## Product / Process Change Notification

**PCN No:** PCN-2019-06-04

### Change Title: Printing on Housing

**Product Category:** VAD, VB, VBD, VC, VCD

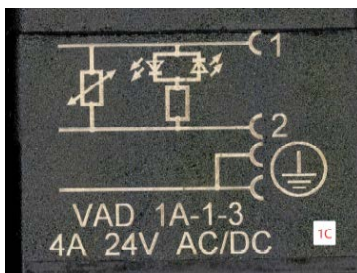
Changing the print process from stamp to laser print.
